SUBJECT: Responds to 860313 request for addl info re SPDS Sys
 consists of qualified SPDS & critical function monitoring
 sys. All inputs to SPDS IE qualified.

Subject: Docket Nos. 50-361 and 50-362
Safety Parameter Display System -- Request for Additional Information
San Onofre Nuclear Generating Station
Units 2 and 3

Response to Request for Additional Information
Concerning the
Safety Parameter Display System

FIGURE II-7: QSPDS POWER SUPPLIES

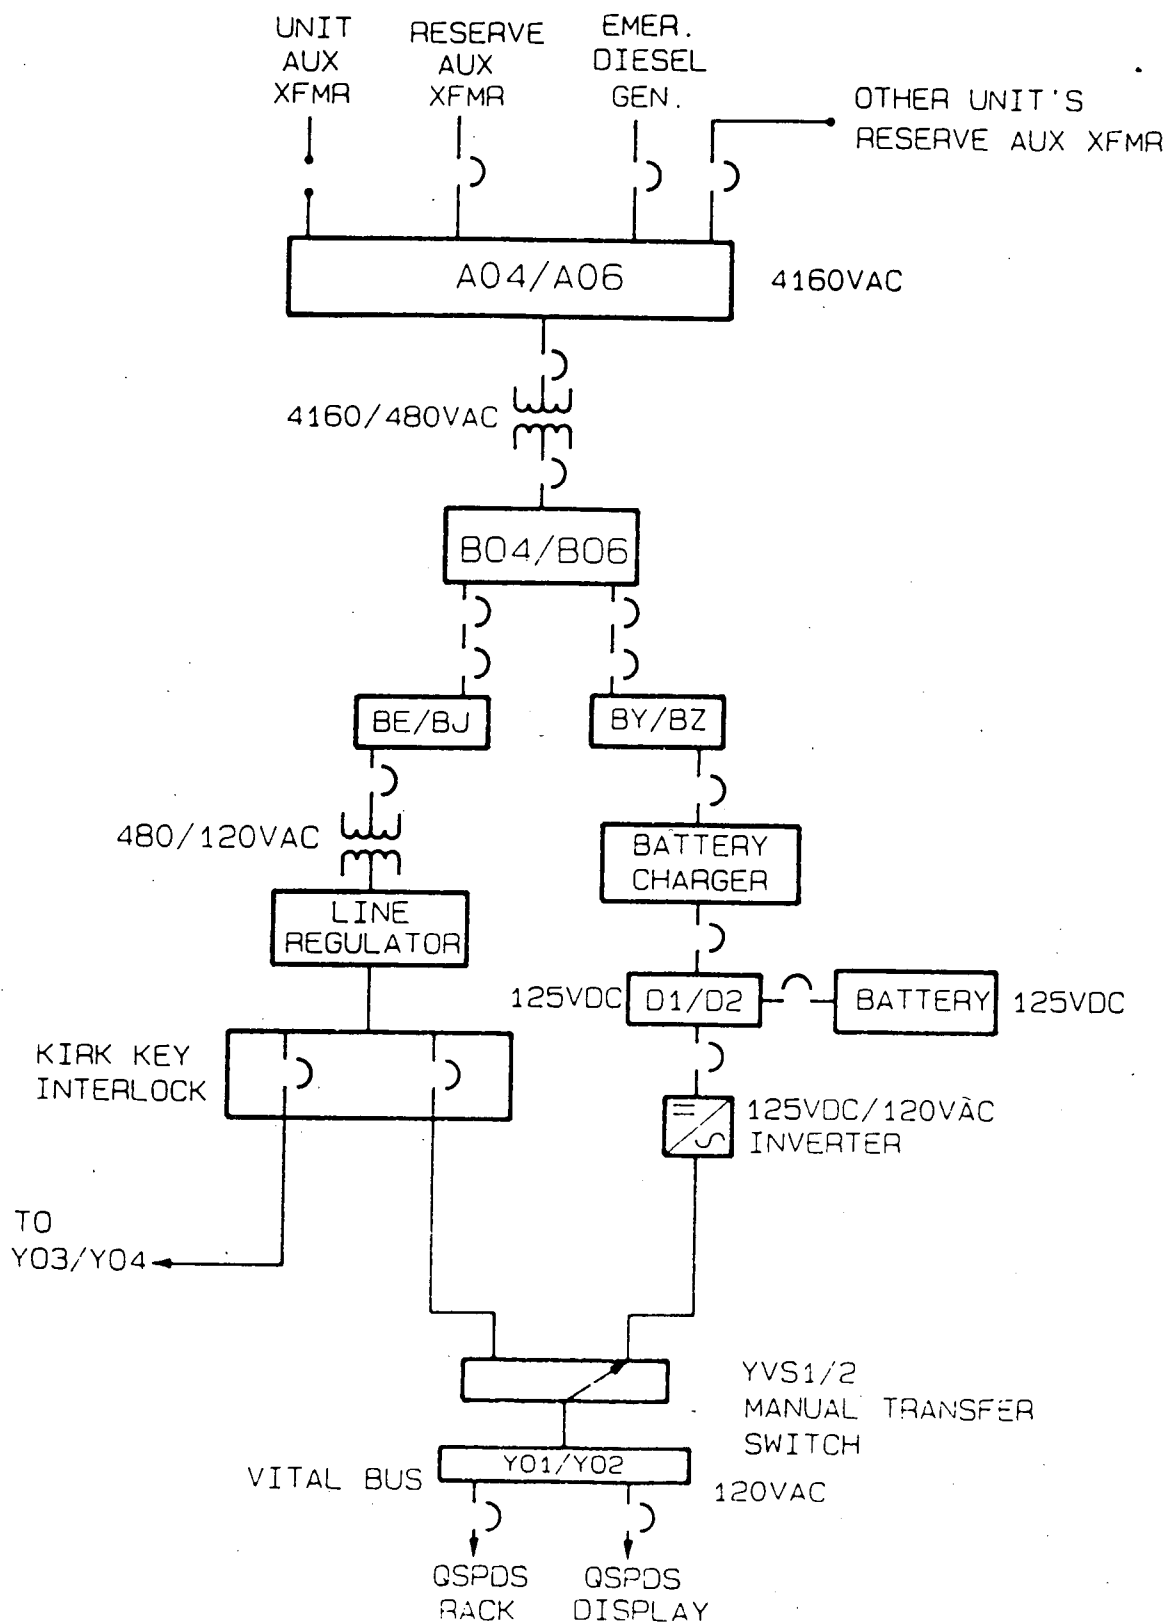
Provide information to verify that the Class 1E isolator is powered from a Class 1E source.

The power supply diagrams for the QSPDS and CFMS are provided in Attachments 3 and 4. The Foxboro Spec. 200 modules are 1E qualified and meet the 1E standards as discussed in San Onofre Units 2 and 3, FSAR, Section 7.
